TITLE: WIRING DIAGRAM 3.5 SBCG MULTI-PORT

SCALE NONE	SIZE E	DRAWING NUMBER 54609
SHT. 1 of 1		REV. C

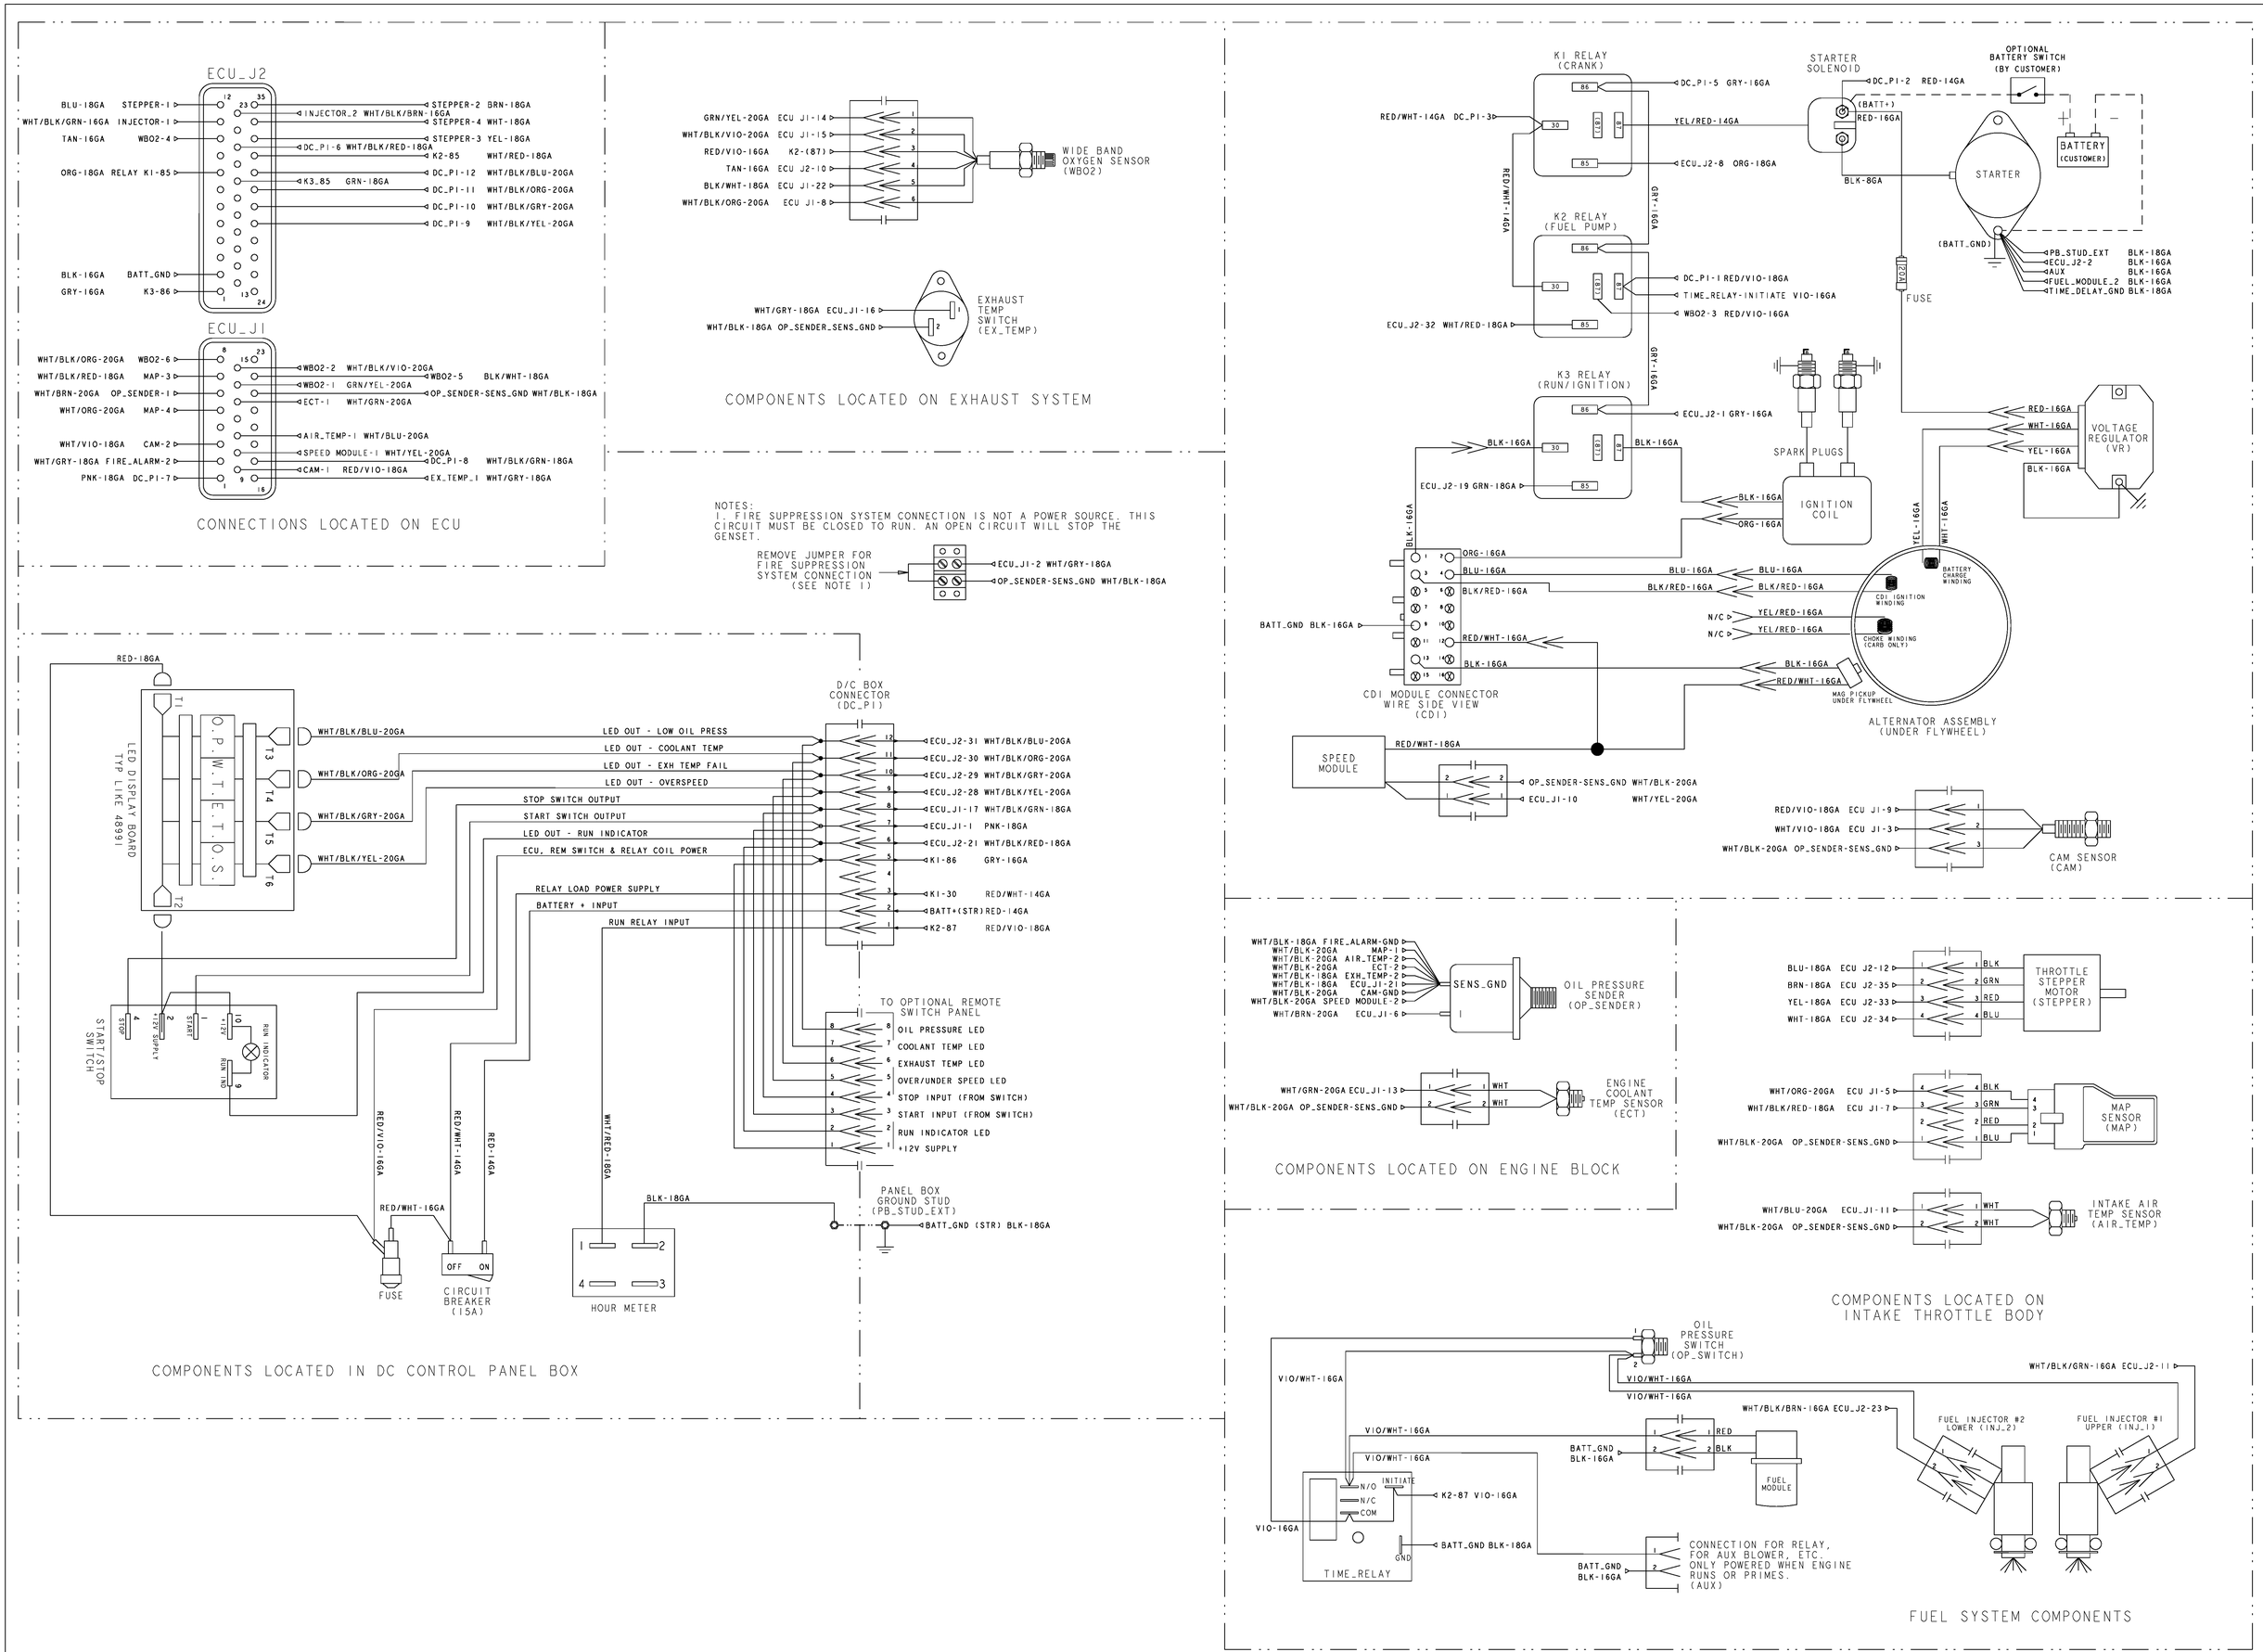
ECO NO.	DATE	REV.	REVISION RECORD	AUTH.	DR.BY
6703	8-17 2010	A	REMOVED SPEED MODULE; ADDED CRANK SENSOR		GA
6823	9-9 2011	B	REMOVED CRANK SENSOR, ADDED SPEED MODULE RENAMED MODEL NAME TO 3.5 SCG		GA
6831	10-26 2011	C	CAM-1 WAS CONNECTED TO K2 PIN (87), NOW IS ECU J1 PIN 9		GA
